# Modifying PCI SS Boards for 3.3 V Power

— Engineering Design Team, Inc. April, 2007

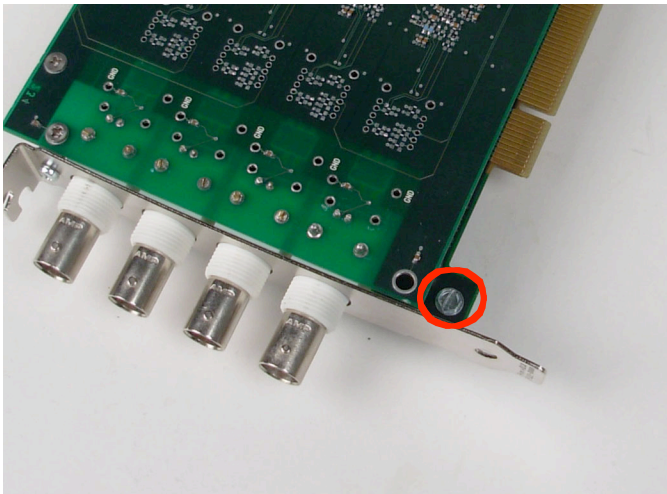
1. Remove the PCI SS board assembly from the host computer.
2. Detach the mezzanine board from the main board:
  - a. Unscrew the screws at the four corners of the board assembly.
  - b. For Combo boards, unscrew the hexagonal standoffs on either side of the connectors, securing the mezzanine board to the back panel.

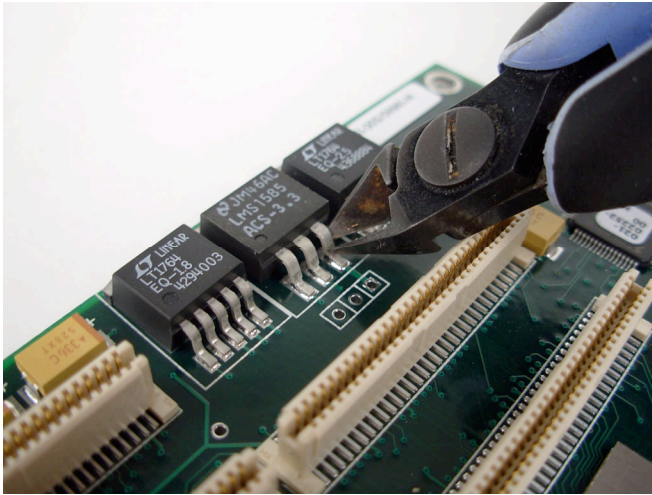
For other boards, unscrew the screw securing the back panel to the main board:

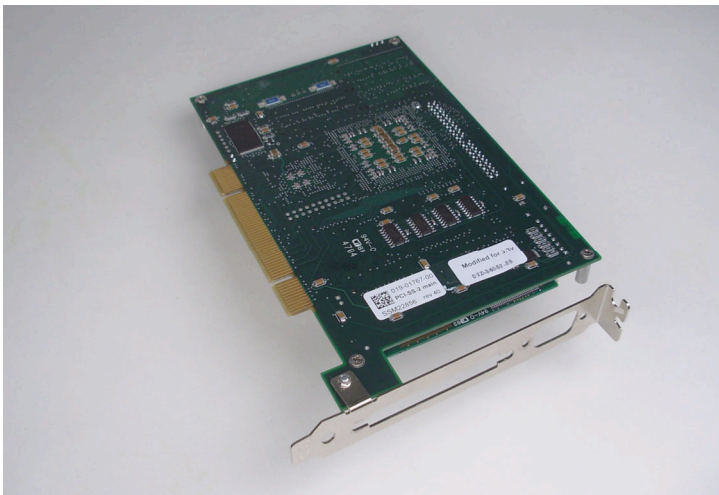
3. Holding the main board parallel to the floor with the PCI Bus connector pointing rightward, locate the middle voltage regulator of three at the edge of the board farthest from you.
4. With wire cutters, carefully cut its rightmost pin.

5. Bend the clipped pin to ensure that the now-separate parts cannot contact each other.
6. Turn the board over and place the new sticker that came with these instructions beside the existing part number sticker, so that you can easily tell that the main board has been altered.
